Re: 4072 NE Timberlake Court (Lot 53, The Trails of Park Ridge)

Vista Structural Engineering, LLC, was asked to address the following question from the framer for the house being built at 4072 NE Timberlake Court:

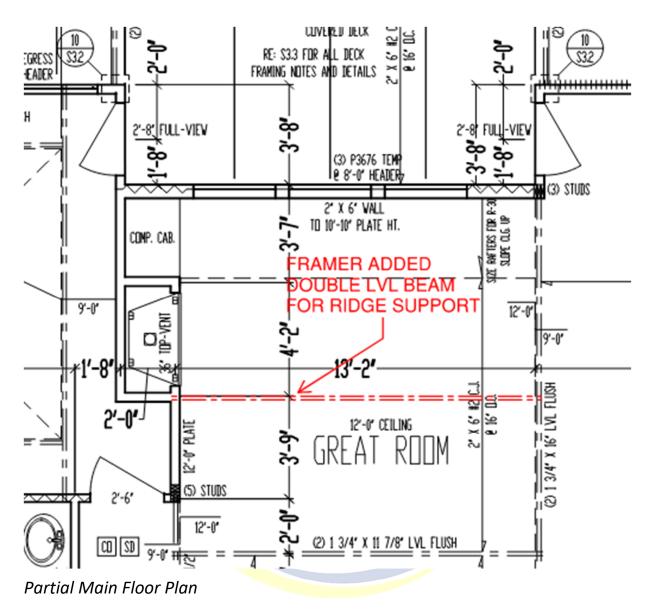
1. An LVL was added for ridge support for the ridge entering the house from above the back porch. Please provide support under the ridge, in the first floor system. The LVL beam was added above the great room, as shown on the attached partial main floor plan. We recommend adding a double 2x10 joist under the end of this LVL beam, in the main floor system, as shown on the attached partial foundation plan.
